PROPOSED RESIDENCE AT:

325 VIA LINDA

DAILEY JANSSEN ARCHITECTS

ROGER P. JANSSEN AR-14785
ARCOM # ARC-23-014
TC # ZON-23-029

SOUTH-NORTH CROSS SECTION

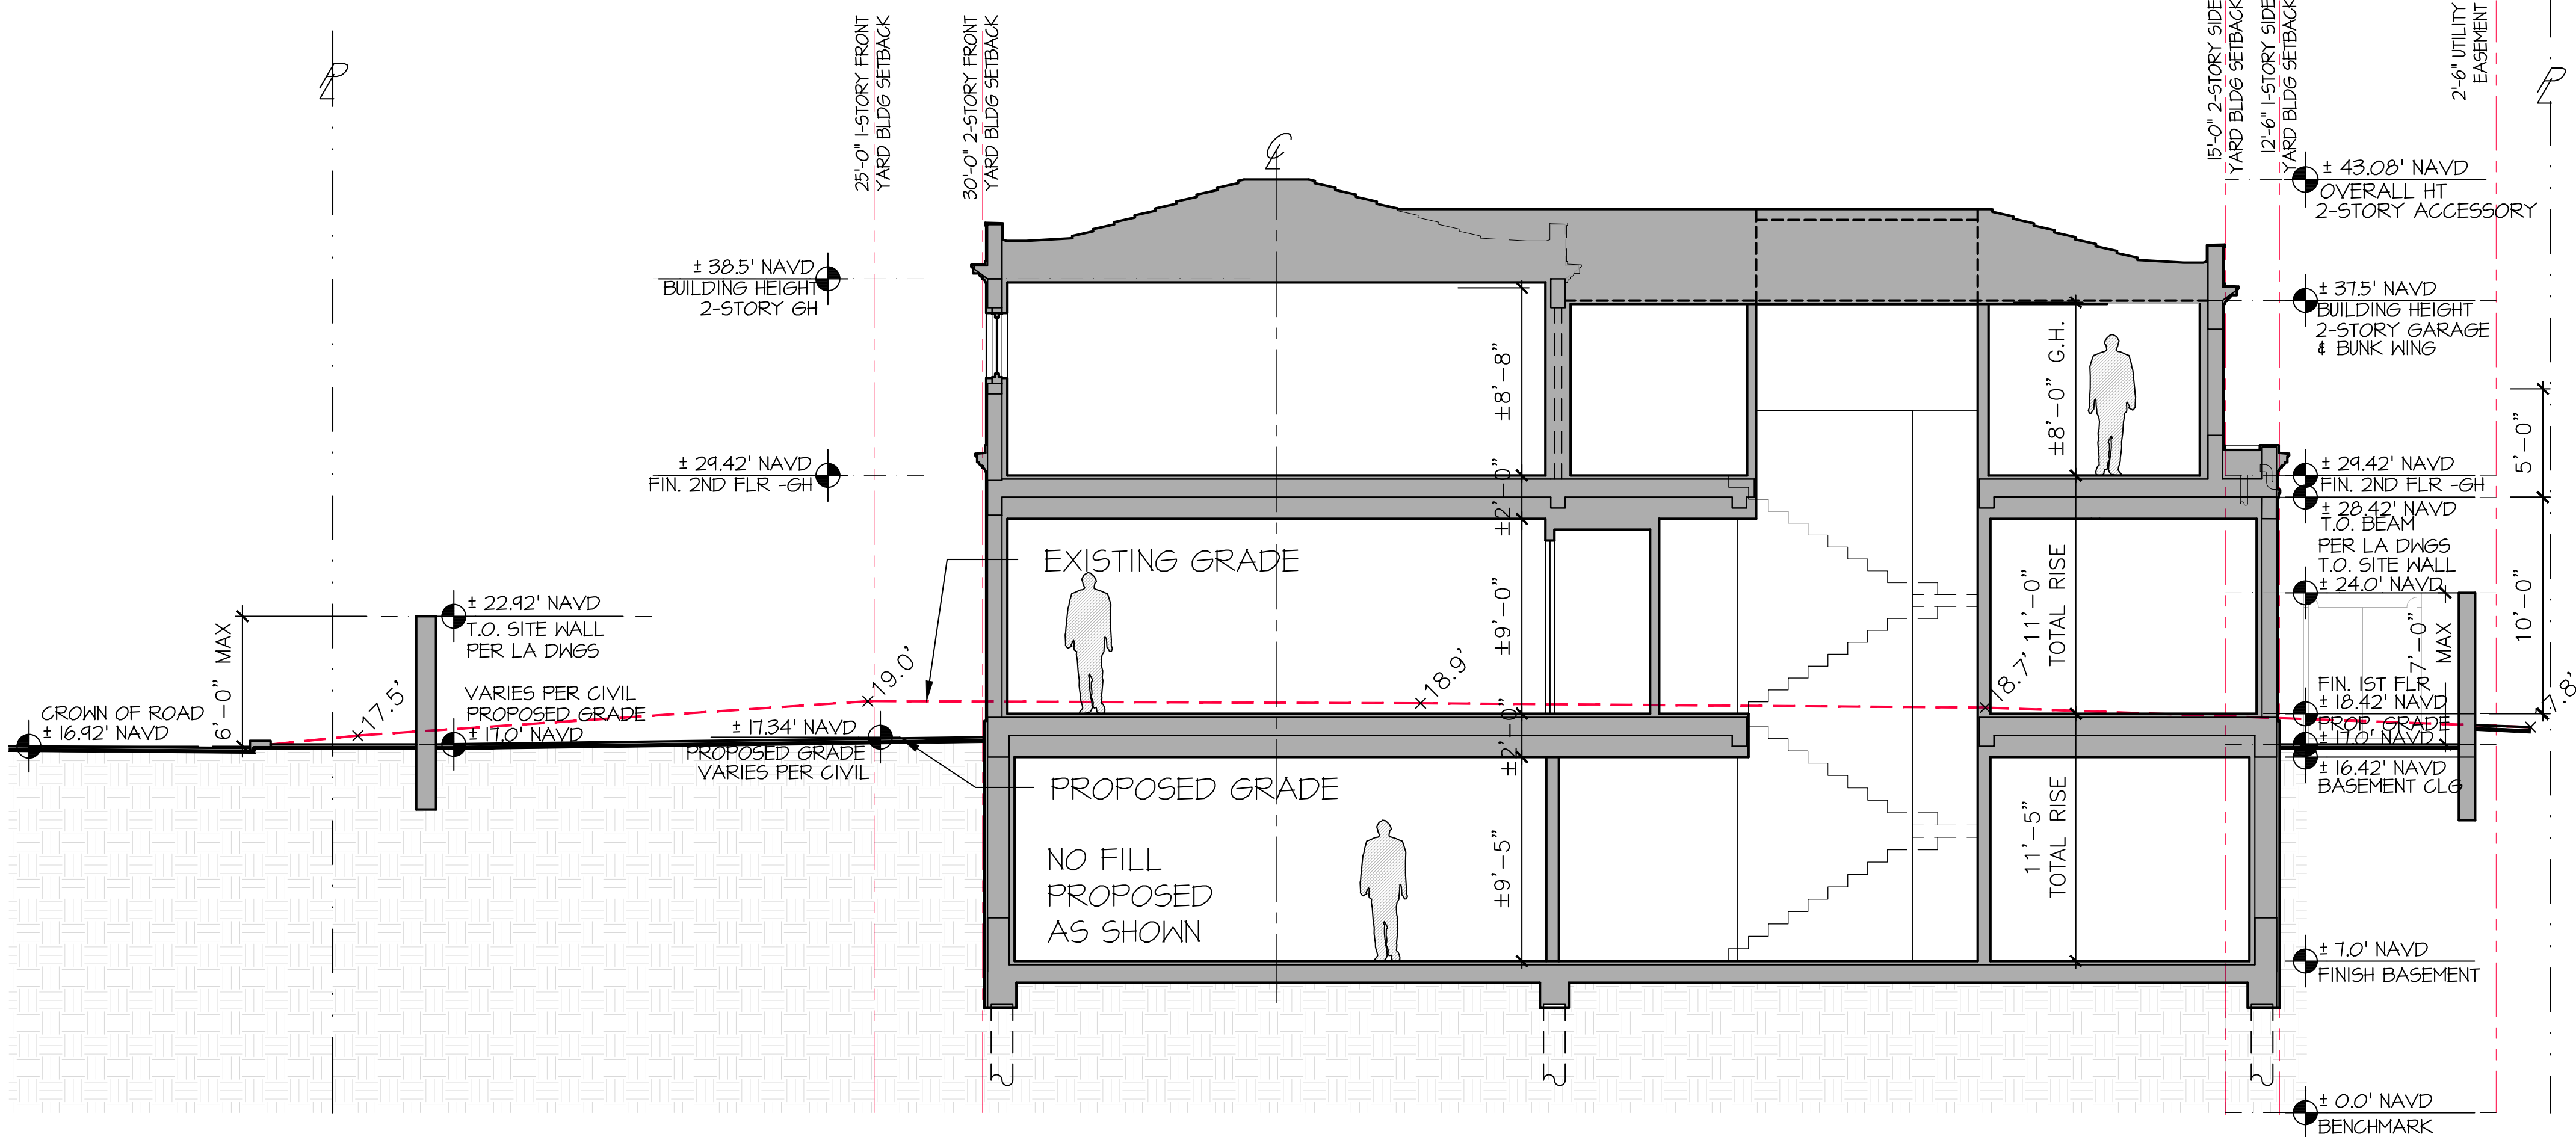
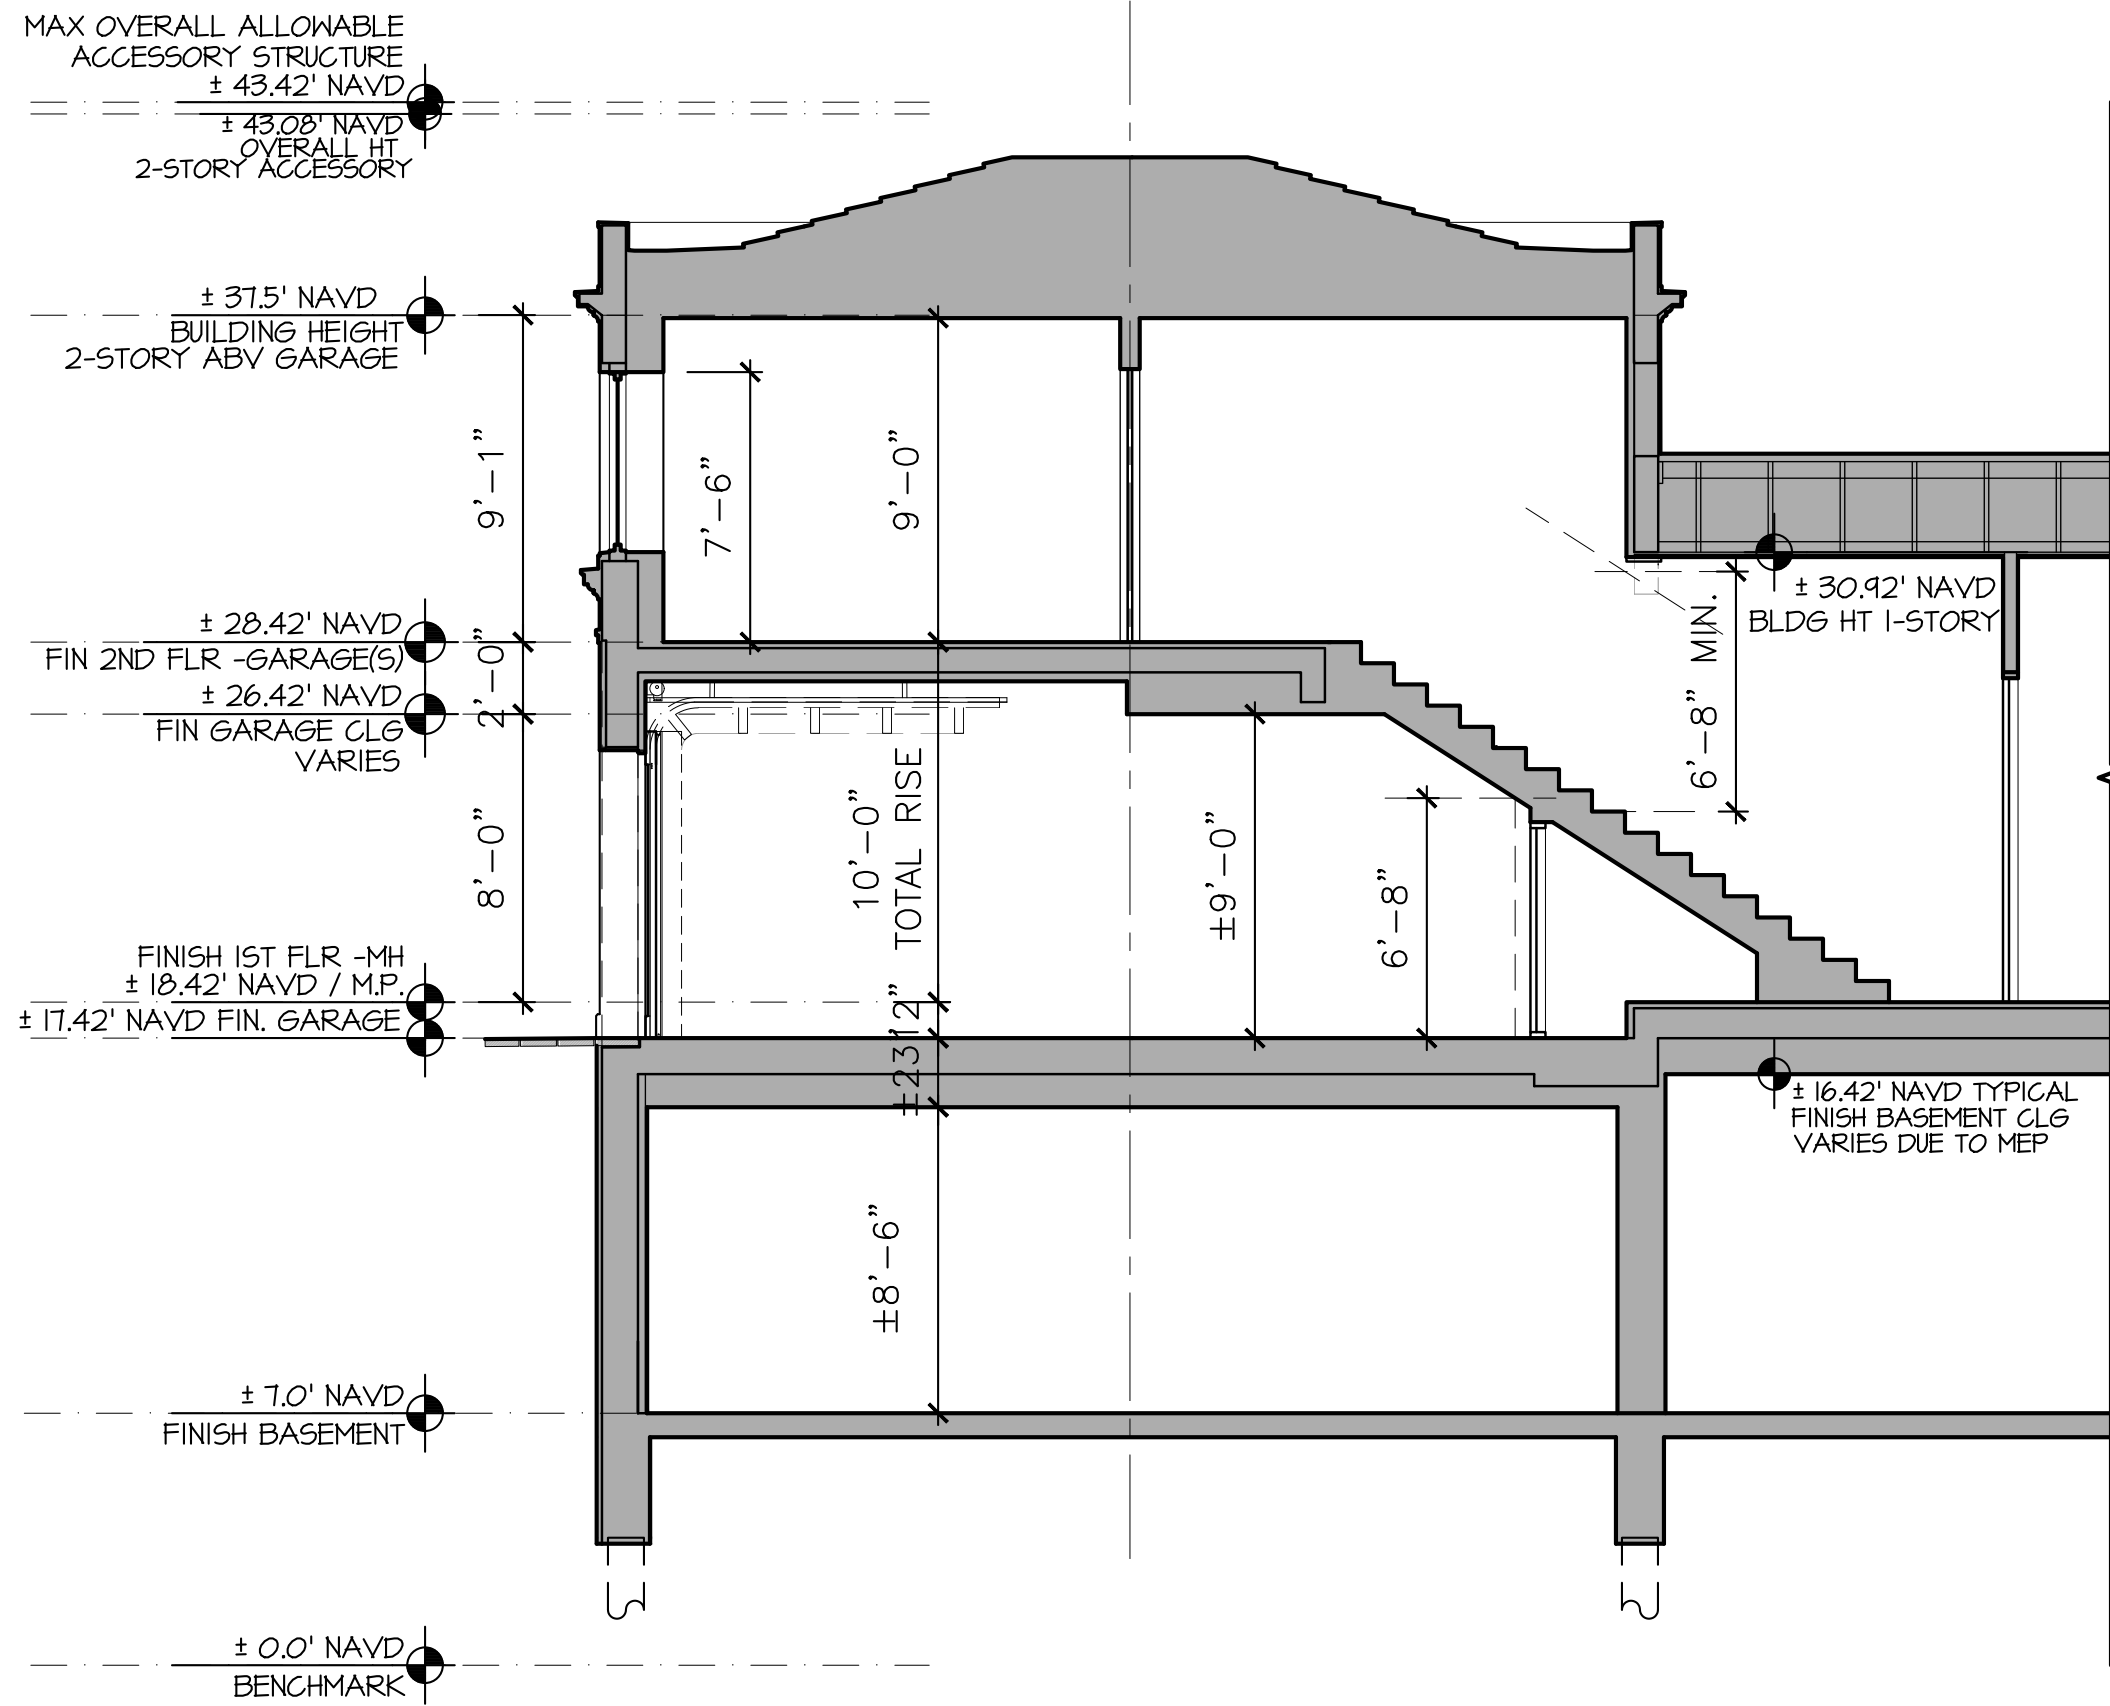
- LOWER PARAPET WALLS AND REVISE ROOF PITCH TO 4:12
